NUMBER
DEP16187

1. Addendum issued to move bid opening date from May 07, 2013 to May 22, 2013 at 1:30 P.M.
2. To provide Questions and Answers regarding the original RFQ.
3. To provide revised drawings.
4. To provide mandatory pre-bid sign-in sheet.
5. To provide revised Contractor's Bid Sheet
6. To provide Addendum Acknowledgement.

DEP16187
Wheatley Branch (Luthy) Portals
Addendum #2

PROFILE VIEW, TYP.

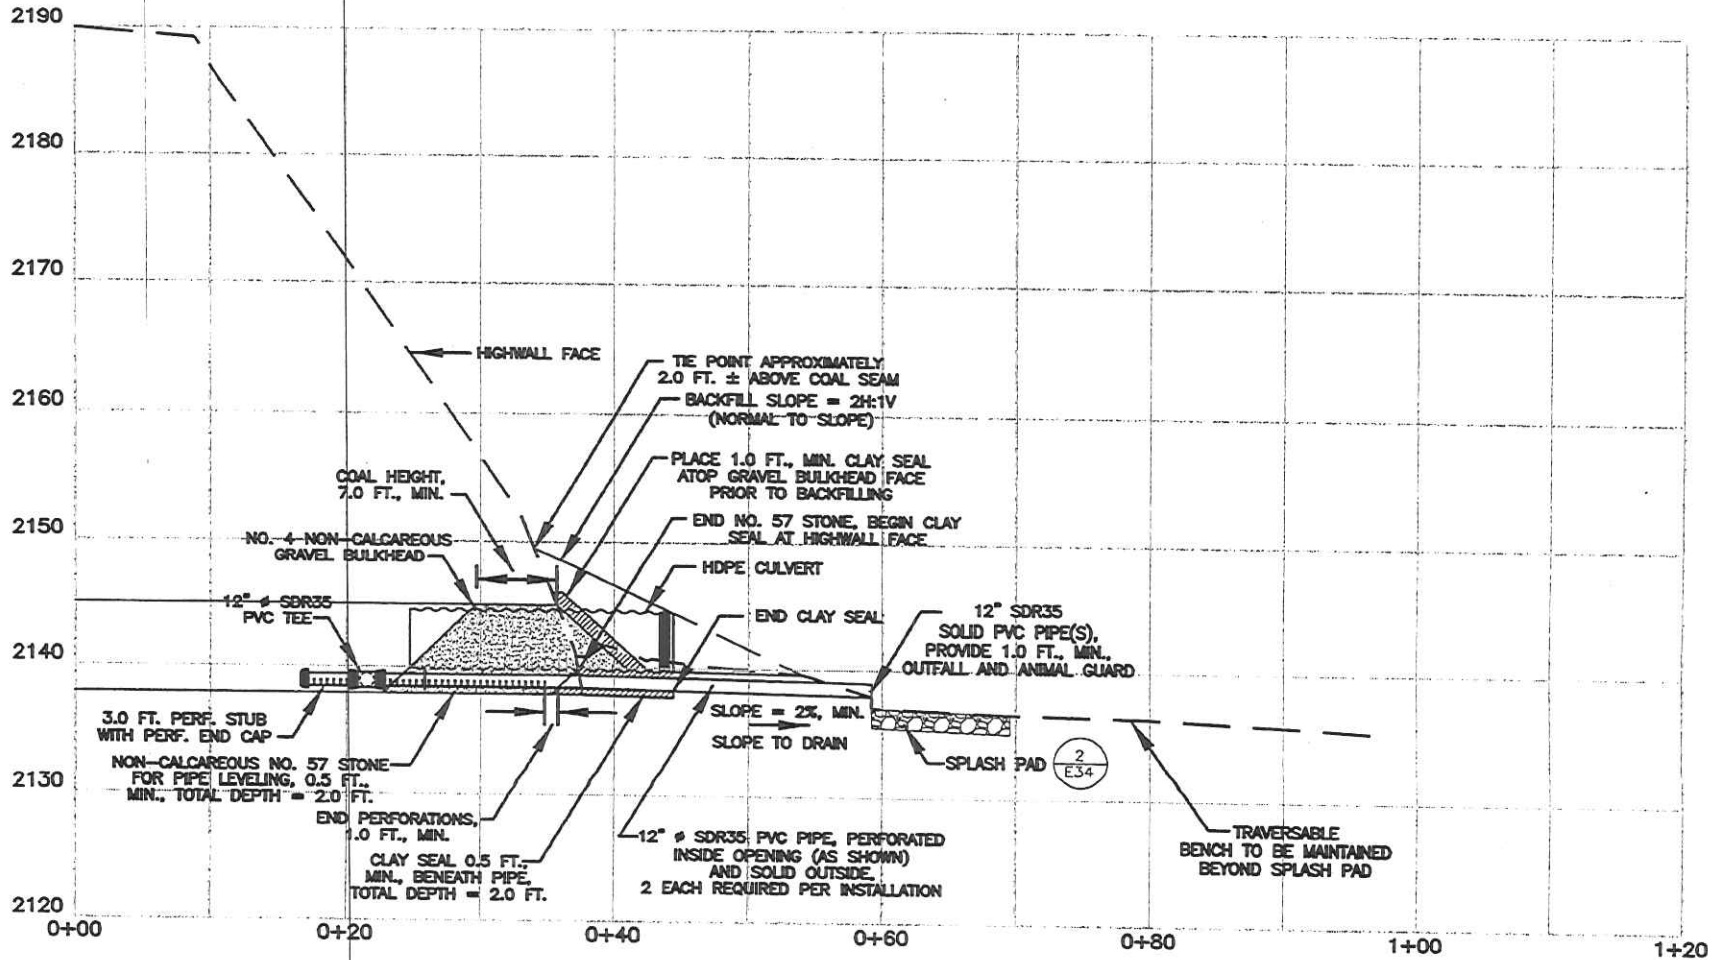
- Item 14: Q - Will all the mine seals have conveyance pipes across the bench?
A - No. They will drain to splash pads. We are concerned with the effective sealing of portals on this project. A revised seal drawing has been attached. We do not desire to infringe on the existing bench with any part of the mine seal (soil cover, pipes, etc.). It appears that most portals are recessed enough to permit the installation of a normal seal with a 2:1 cover slope. There are several portals where the proximity to the bench prohibits a 2:1 cover slope. In these cases, the cover slopes, pipes, etc. will be adjusted accordingly. Also, it should be noted that almost all of the portals are dry. Wet seal portals will discharge onto a splash pad and therefore the mine pipes (conveyance pipes) should not extend onto the bench. Revised mine seal drawings (for wet seal, modified wet seal, and bat gate) are attached as Items 21, 22, and 23 below. The revised mine seal drawings are to replace the original profile drawings on Sheets 32, 33 and 34.

Item 21: This revised wet mine seal profile view should replace the profile view on Sheet 32.

1. TWO (2) JOINTS (28.0 FEET) OF MINE SEAL OUTLET PIPES SHALL BE INCLUDED IN THE UNIT PRICE BID FOR "WET MINE SEALS" REGARDLESS OF WHERE THESE PIPES END IN THE INSTALLATION.

2. THE MINE SEAL CONVEYANCE PIPE LENGTHS VARY AND SHALL BE INCLUDED IN THE UNIT PRICE BID FOR "MINE SEAL CONVEYANCE PIPES". MINE SEAL CONVEYANCE PIPES BEGIN AT THE END OF THE MINE SEAL OUTLET PIPES AND EXTEND TO THE PLANNED OUTFALL.

3. THE PERFORATED END CAP LOCATED INSIDE THE MINE AT THE END OF THE ONE TO THREE FOOT (1.0' TO 3.0') STUB SHALL HAVE A RUBBER GASKET, PLACED ON THE UPSTREAM END OF THE STUB AND SCREWED IN PLACE.

4. THE STONE BULKHEAD SHALL BE IN CONTACT WITH COAL ROOF FOR A DISTANCE EQUAL TO THE OPENING HEIGHT OR A MINIMUM OF 6.0 FEET. THE INSIDE AND OUTSIDE STONE BULKHEAD FACES SHALL BE CONSTRUCTED AT THE ANGLE OF REPOSE OF THE NO. 4 NON-CALCAREOUS STONE PLACED.

5. 1 1/2" CRUSHER RUN STONE SHALL MEET THE GRADATION REQUIREMENTS FOR CLASS 1 AGGREGATE IN TABLE 704.6.2A OF THE WVDOT SPECIFICATIONS FOR ROADS AND BRIDGES.
